ANNUAL REPAIRS TO S.M.H. SOCIETY SHOPPING CENTRE.

ORDER UNDER SECTION 96 (2) OF ACT, III OF 1901

With reference to his application, dated _____ 192 .
theirMr. Sayabali Abdullmussemi Maudhumi is informed
Messrs. arethat the plan submitted by him for building a house
them_____ on plot No 17 Survey Sheet C-5
situate in _____ Street, Market
Road

- THE PLAN SHOWING THE SHOP TO BE REBUILT -

SECTION ON. A. B

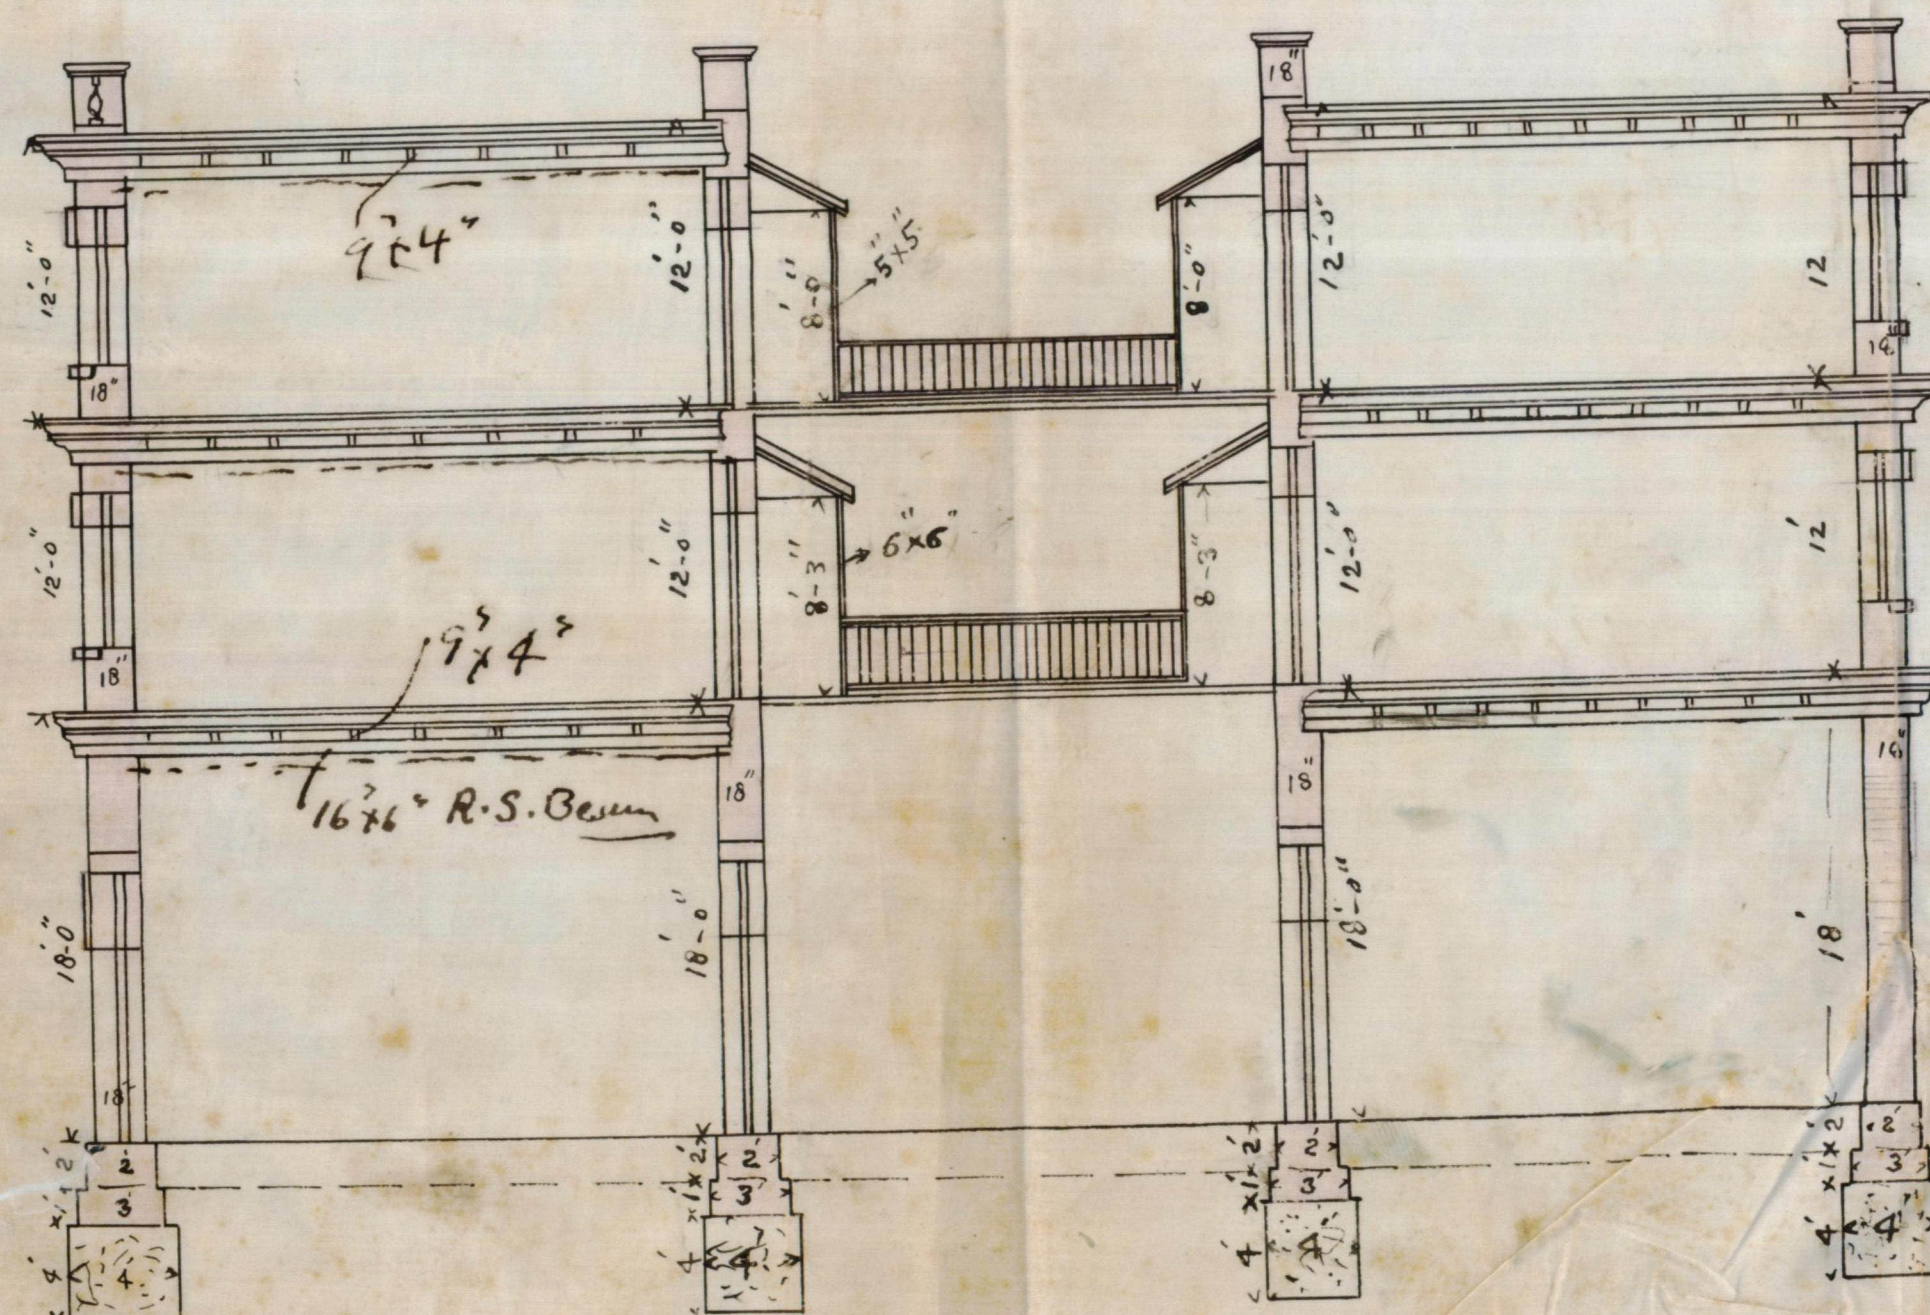
- 1. Kitchen + nohani are not shown in section*
- 2. Beam should be provided below the p. wall*
+ gallery

*The girders for 24' span must be Rolled Steel beam
 16" x 6", the front joints should be 7" x 4" three feet apart,
 the rear joints ought to be 9" x 4" 3' apart.
 Below the P. Wall 13" x 7" beam should be provided.*
